To: X3T10.1 Membership
 Subj: Termination schemes for PH2
 Date: 96-04-24 11:13:37 EDT
 From: pmurfet@vnet.ibm.com

X3T10.1/96a137r0

At the Winchester meeting IBM were asked to look at the relative merits of the various termination schemes available for SSA40, the results of this work will be presented at the Burlington meeting. The termination scheme that gave the best error rate is illustrated below.

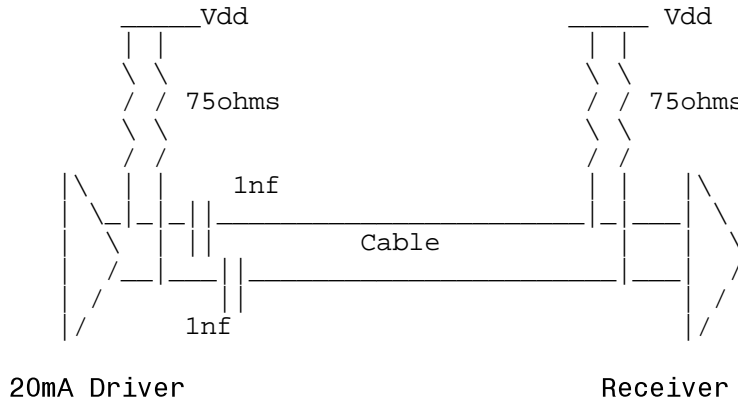
IBM will be recommending the adoption of this scheme for SSA40. Below you will find some general comments on the scope of PH2 and PH1 followed by line by line alterations to PH2 required for the inclusion of the termination scheme shown.
